Attorney Docket No.: C6656(C)
Serial No.: 10/748,038
Filed: December 30, 2003
Confirmation No.: 6775

Amendments to the Drawings:

REMARKS

FIG. 1

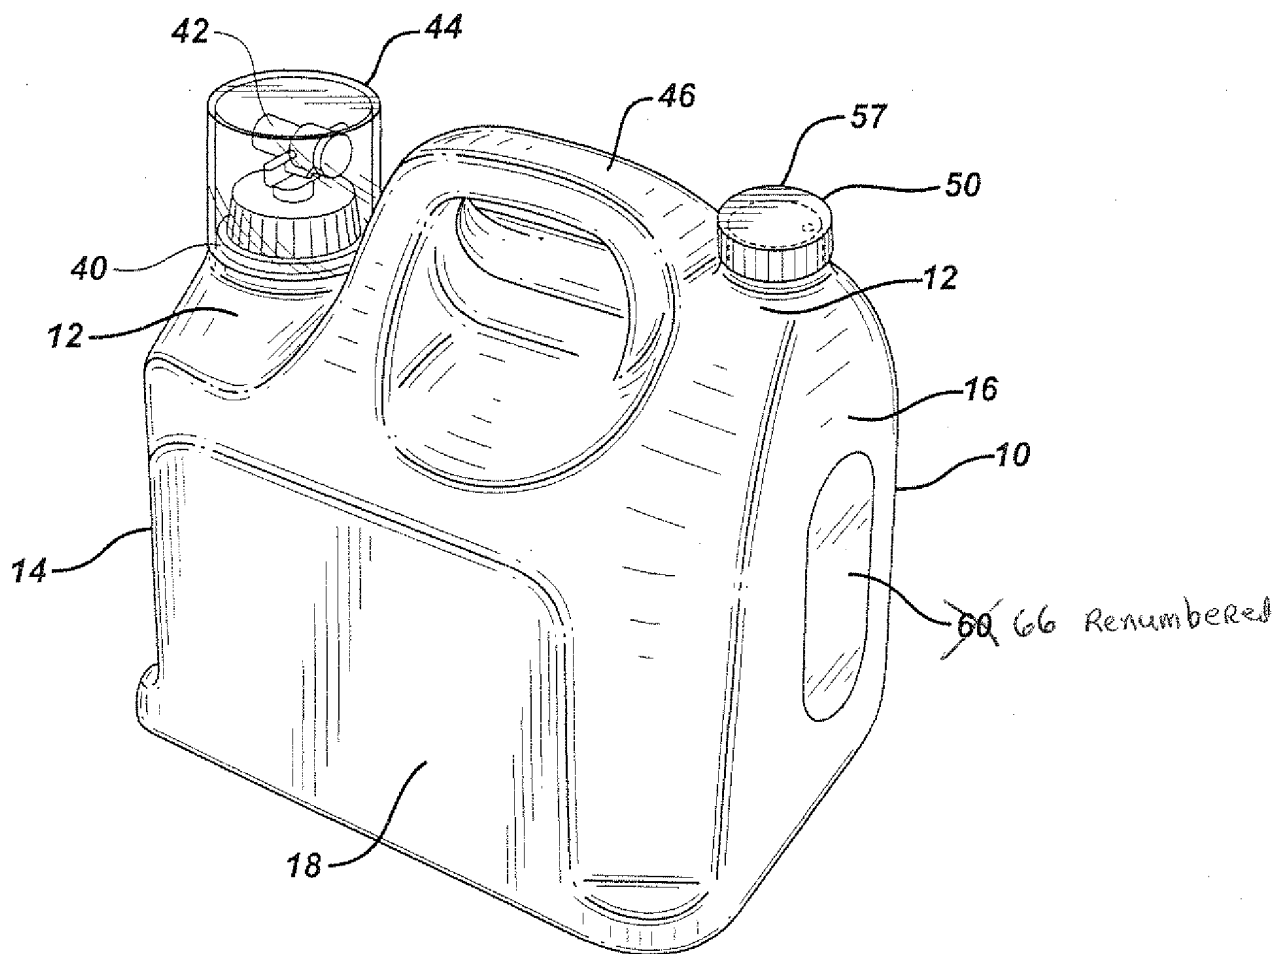
The attached sheets of drawings include changes to Figs. 1, 2 and 4. These sheets, which include Figs. 1, 2 and 4, replace the original sheets including Figs. 1, 2 and 4. In Figures 1, 2 and 4, element 60 has been changed to 66.

FIG. 2

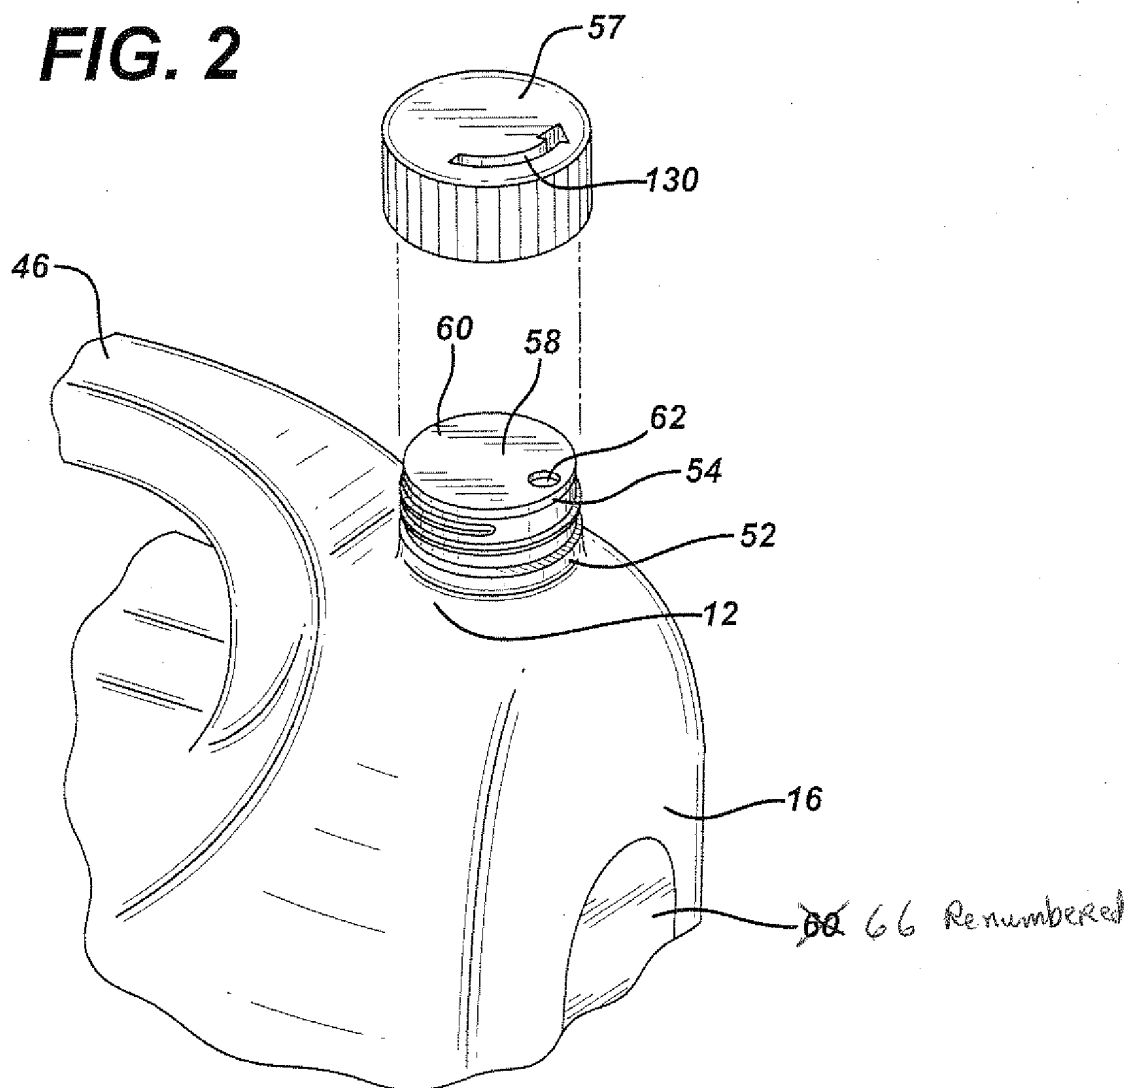
Independent claim 1 has been amended to incorporate original claims 3 and 4. Further, claim 1 has been amended to identify that the aperture in the patch is positioned off-center from a central point of the patch. Figures 2 and 4 support the off-center arrangement of aperture 62. Independent claim 9 has been similarly amended.
